Subject: FRONT BRAKE SQUEAK WHEN COLD	Bulletin No: 04-007/06
	Last Issued: 9/1/2006

This bulletin supersedes the previous bulletin 04-001/05, issued 06/03/2005. The APPLICABLE MODEL(S)/VINS, REPAIR PROCEDURE, PART(S) INFORMATION, and WARRANTY INFORMATION have been revised.

2004-2006 Mazda3

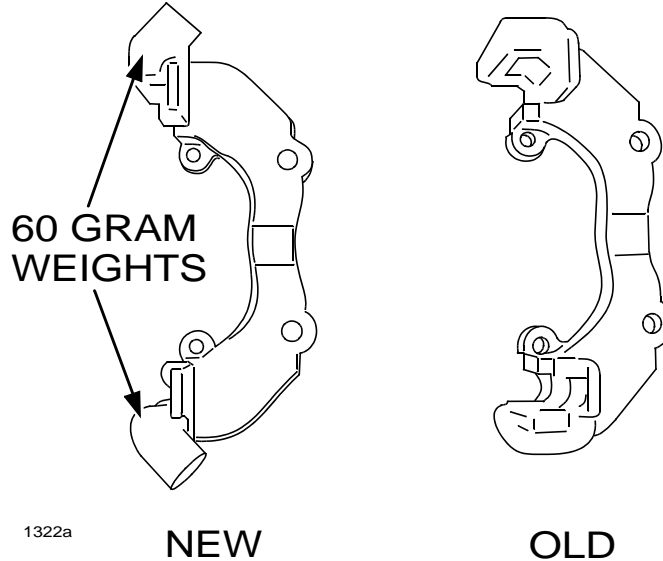
- If service bulletin 04-001/05 was already performed on this vehicle, the updated caliper mounting supports will already be installed. Verify that the updated supports are installed through visual inspection.
 - If updated caliper mounting supports are not installed, continue with REPAIR PROCEDURE "A".
 - If updated caliper mounting supports are installed, proceed to REPAIR PROCEDURE "B".
2. Replace front brake caliper mounting support assemblies and front pad & shim set with the modified parts

- Use new bolts 9975-60-230, two (2) per mounting support. The thread pitch is different than original. Do not reuse original mounting support and bolts.
